Rezoning Transportation Analysis
Petition Number: Insert Zoning Petition #2021-018
General Location Identifier: Tax ID 07908301

Revision Log:	Date	Description
	02-25-21	First Review (EL)
	03-25-21	Second Review (KP)

Transportation Summary

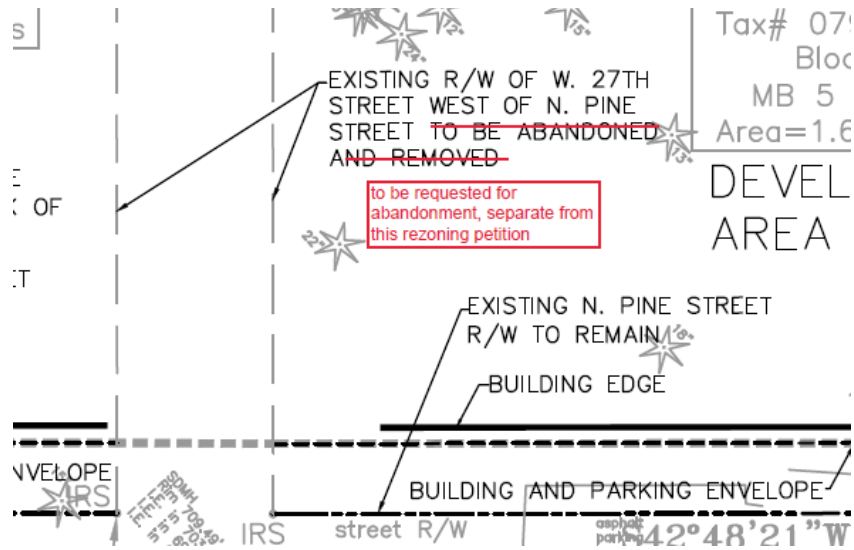
5. ~~A site plan note specifying dedication and fee simple conveyance of all rights-of-way to the City before the site's first building certificate of occupancy is issued is needed. CDOT requests rights-of-way set at 2' behind back of sidewalk where feasible.~~
6. ~~A site plan note specifying that all transportation improvements will be approved and constructed before the site's first building certificate of occupancy is issued is needed. The petitioner may phase transportation improvements if said improvements and phasing are explicitly described in site plan notes.~~
7. On sheets RZ-1 and RZ-2, remove call-out to abandon and remove W. 27th Street. Also, remove the site conditional note 3. Access, Buffers, Screening, Open Space and Pedestrian Circulation, Note I. The abandonment of W. 27th Street is not consistent with the USDG Standards (see image below).

Update to Comment as a Result of 03/16/2021 Site Plan: Remove note 3.K. This is covered in the site plan call-out, and is a separate process from the rezoning.
